PCN/17/026/PM+MD
Product range: DC2 / Circular connectors

Date: 2017-11-24

Title: M12 Slim Design shielding element improvement - External

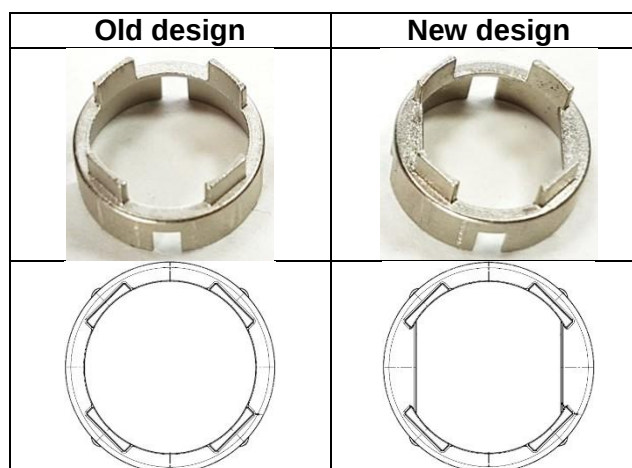
The inner contour of the shielding element of M12 Slim Design straight connectors has been changed from round shape to double D shape. This improvement secures the proper assembly and avoids the displacement of the contact carrier in assembled condition.
